**Authors' response to Interactive comments** on "Spatially distributed water-balance and meteorological data from the Wolverton catchment, Sequoia National Park, California" by Roger C. Bales et al.

**Anonymous Referee #1**

Figure 1. The soil volumetric water content (VWC) data from points 5, 4, and 3, have been graphed here for depths of 10 cm, 30 cm, and 60 cm.

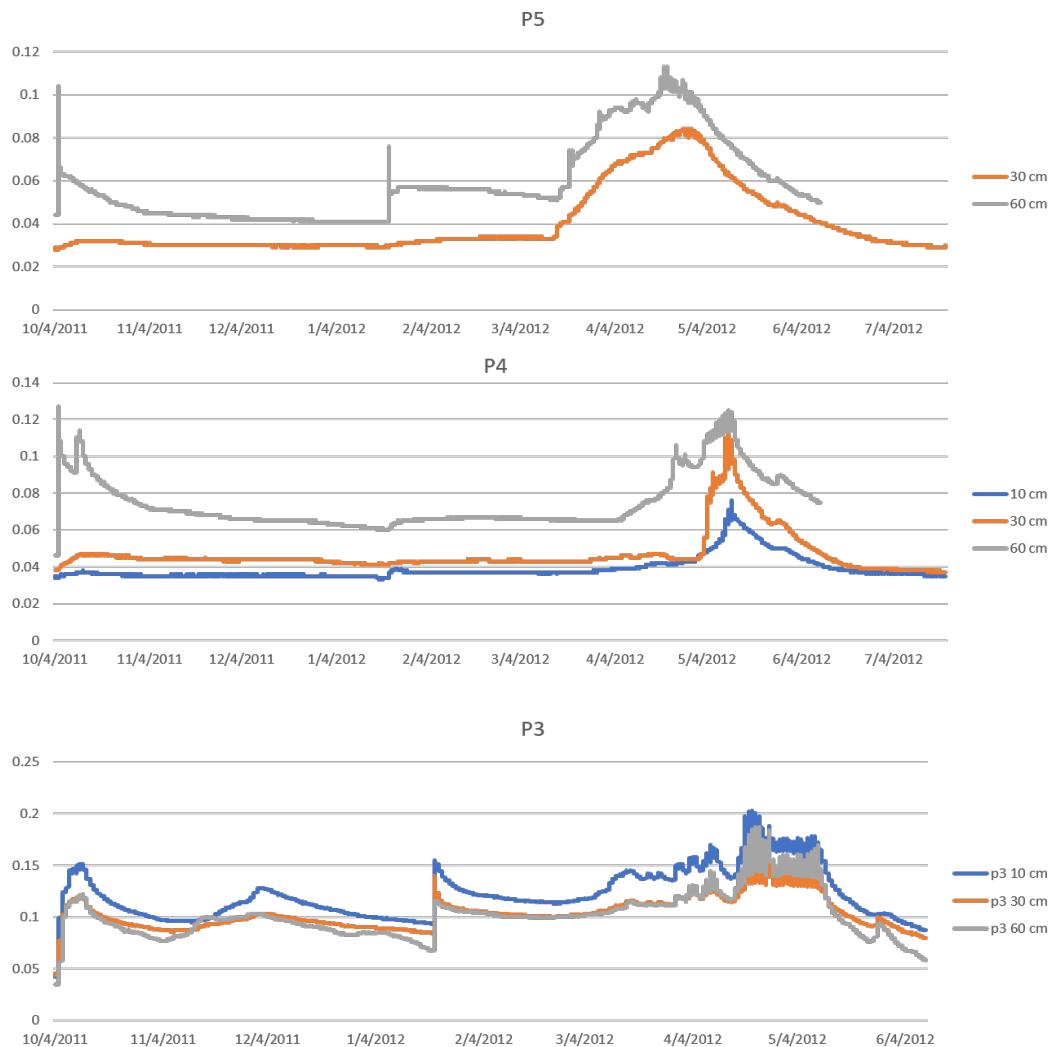
5. At Site 3, there seems to be an issue with soil temp\_P3\_0\_10 cm. The values seem too high, relative to the other sensors, for \_ October 2011 through June 2012.

**Response:** Yes, the values for the soil moisture sensors are higher than those at the same depth at P4 and P5 (at the same site), but the moisture wet-up and drying patterns at the sensor in question track well with sensors in the same pit at 30 cm and 60 cm (See Figure 1). There was no obviously erroneous data to remove, and there are pit siting variations that may explain the differences (for instance, P3, or pit at point three, is located closer to boulders and exposed bedrock that may funnel water to the pit, and it may receive more solar energy than P4 as it is further from the tree bole). Instead, the patterns could indicate that sensors at some depths in P4 and P5 may be aging and yield suppressed values, but we have no indication that these are clearly erroneous data. With no obviously erroneous data, we present the data we gathered (with QA/QC for each data processing level).
